Office Action Summary

10/717,356

HOBMEYR, RALPH

Fig. 1

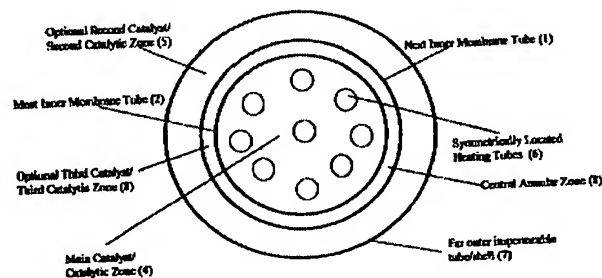
cooling fluid (cool gas) is recycled through a permreactor-separator, which comprises a hydrogen permeable tube (2), wherein hydrogen within the coolant fluid permeates through the later to reduce hydrogen content in the cooling fluid. See col. 3, line 65 to col. 4, line 5.

With respect to claim 2-4, the system further comprises a support layer (1) disposed concentric to the hydrogen-permeable tube (2). See Figure 1. The support layer (1) is a permeable membrane therefore providing a breathable (claim 3) mesh (claim 4) hydrogen permeates. With respect to claim 5, a second layer of hydrogen-permeable material (col. 20, lines 65-68 discloses multiple permeable tubes employed in the permreactor). With respect to claim 6, the central annular zone serves as support between the layers of hydrogen permeable material. See Figure 1. With respect to claim 7, the second catalytic zone (5) serves as a fluid-permeable protective layer disposed about the conduit, protecting the conduit from debris. See Figure 1. With respect to claim 8, the hydrogen permeable tub (1) has a catalyst coating to induce a reaction

between hydrogen and oxygen to produce water. See Figure 1 and col. 3, lines 30-68.

Vasileiadis does not expressly disclose the fuel cell stack in heat transfer communication with the cooling fluid (claim 1).

However, it would have been obvious to one of ordinary skill in the art at the time the instant invention was made to employ the fuel cell stack in heat transfer communication with the cooling fluid in order to control the stack temperature thereby improving fuel cell operation efficiency.
